NO. SI 42NG-050

EASA Airworthiness Directive No. 2013-0025R1 and Austro Engine Mandatory Service Bulletin MSB-E4-007/4

MSB Service Bulletin
No. MSB-E4-007/4

Replacement of Waste Gate Controller

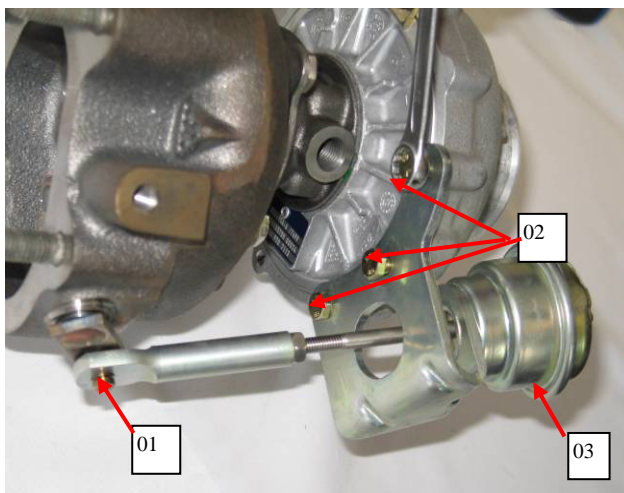
1. Disconnect Hose at the top of the Waste Gate Controller
2. Remove three M6 Bolts [02]
3. Remove Circlip [01]
4. Disconnect rod from waste gate lever and remove waste gate controller [03]

1. Install the three M6 Bolts [02] and torque them with 7 Nm
2. Attach external pump to the top of the Waste Gate Controller and apply pressure till the rod starts to move
3. Connect rod to waste gate lever
4. Adjust Waste Gate Controller according to Engine Maintenance Manual E4.08.04, Chapter 81-00-32.

Note: For fixing of the rod on the waste gate lever use new circlip.
